SAFETY RELATED RECALL

Recall Action
Number: N143v3

Subject: HVAC Inlet Door Linkage Disconnect	Publication No.: N143v3
	Model: Range Rover Velar (LY)
	Model Year: 2018
	Date of Issue: 22 August 2022

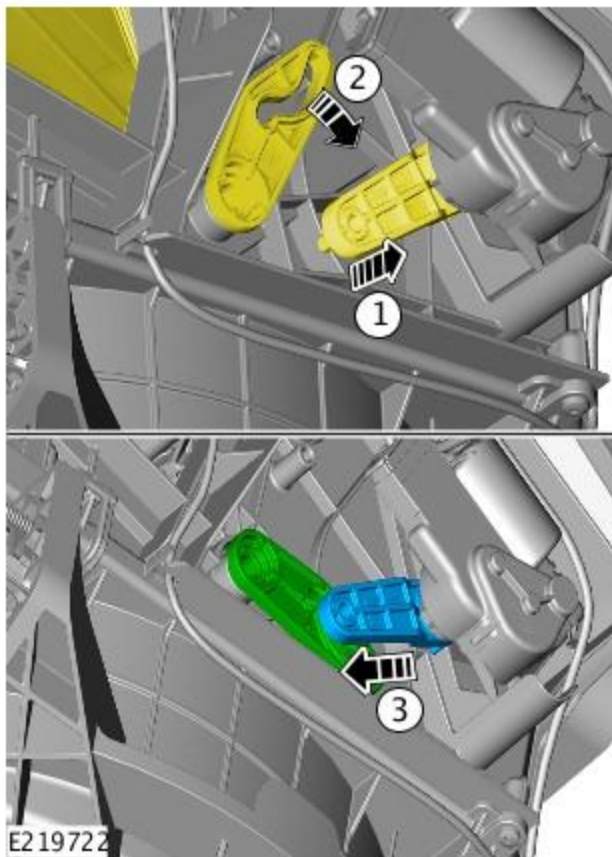
CAUTION: Do not use excessive force to install the actuator lever arm.

Install the recirculation blend door actuator lever arm into the recirculation door.

E221331

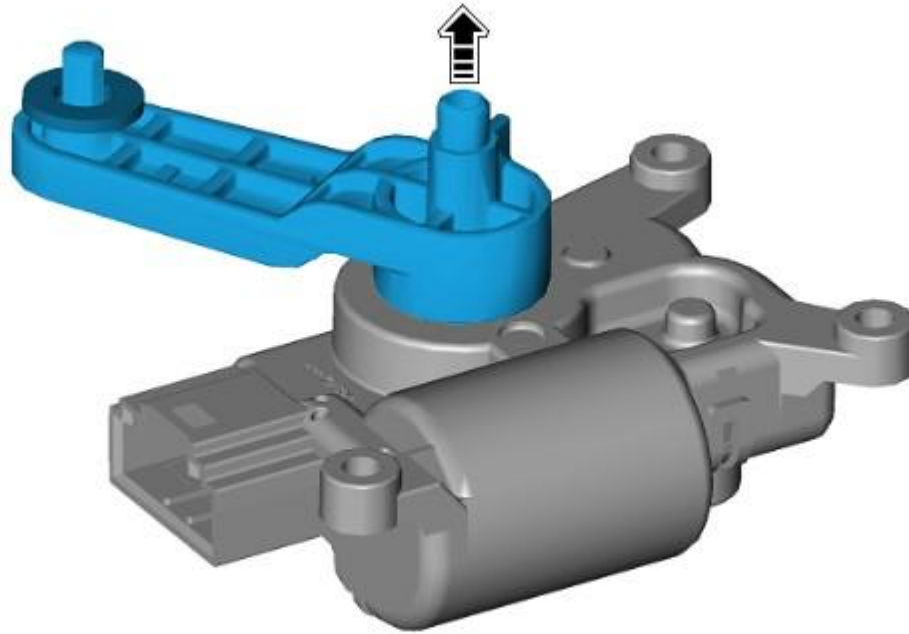
24. Remove the recirculation blend door actuator lever arm from the actuator.

E221333

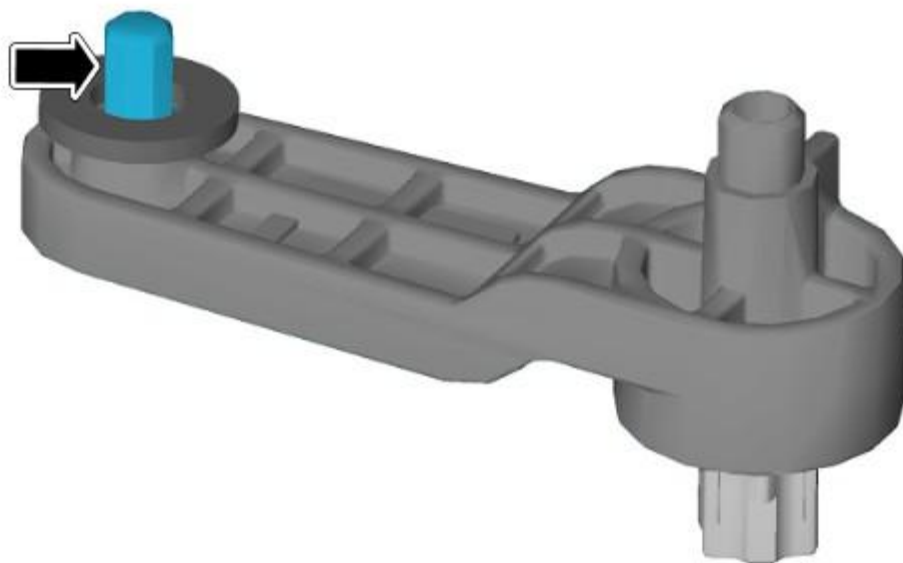
Apply the recovered grease to the new recirculation blend door actuator lever arm as shown.

E221334

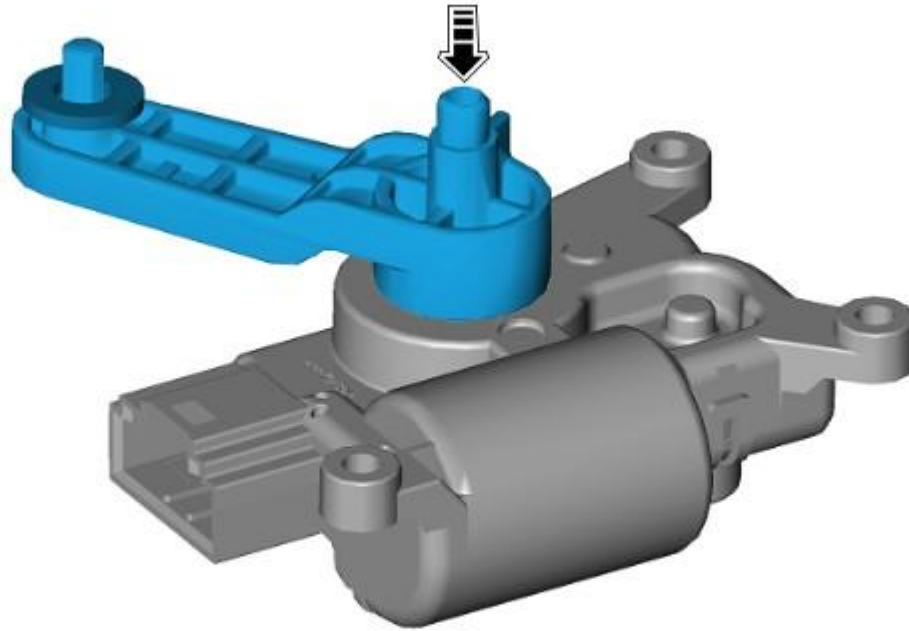
29. Install the recirculation blend door actuator lever arm to the actuator.

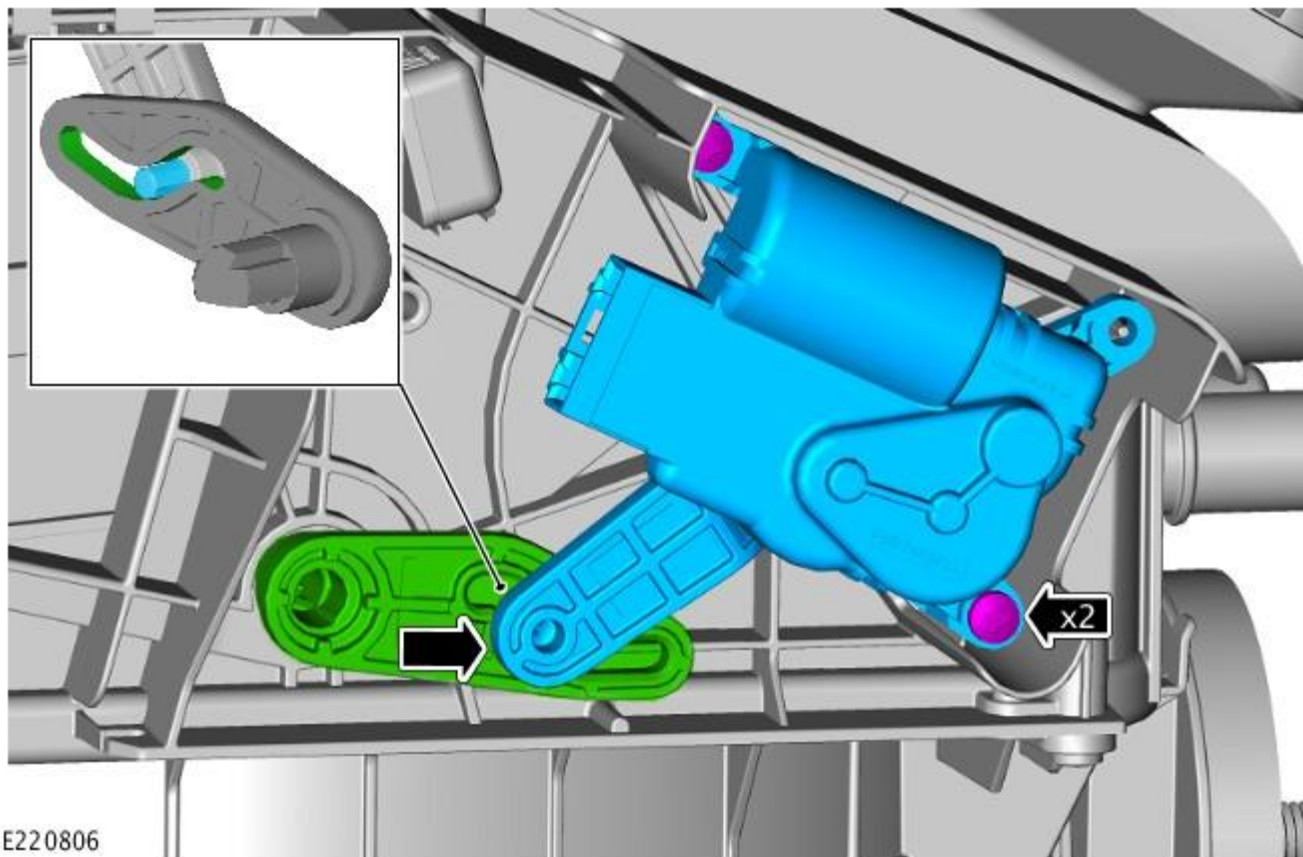
Make sure when installing the recirculation blend door actuator the new retaining screws are used from the link arm kit.

Make sure the recirculation blend door actuator lever arm is located correctly into the blend door lever arm.

Install the recirculation blend door actuator.

- Install the recirculation blend door actuator retaining screws.
- Torque: **1.5 Nm**
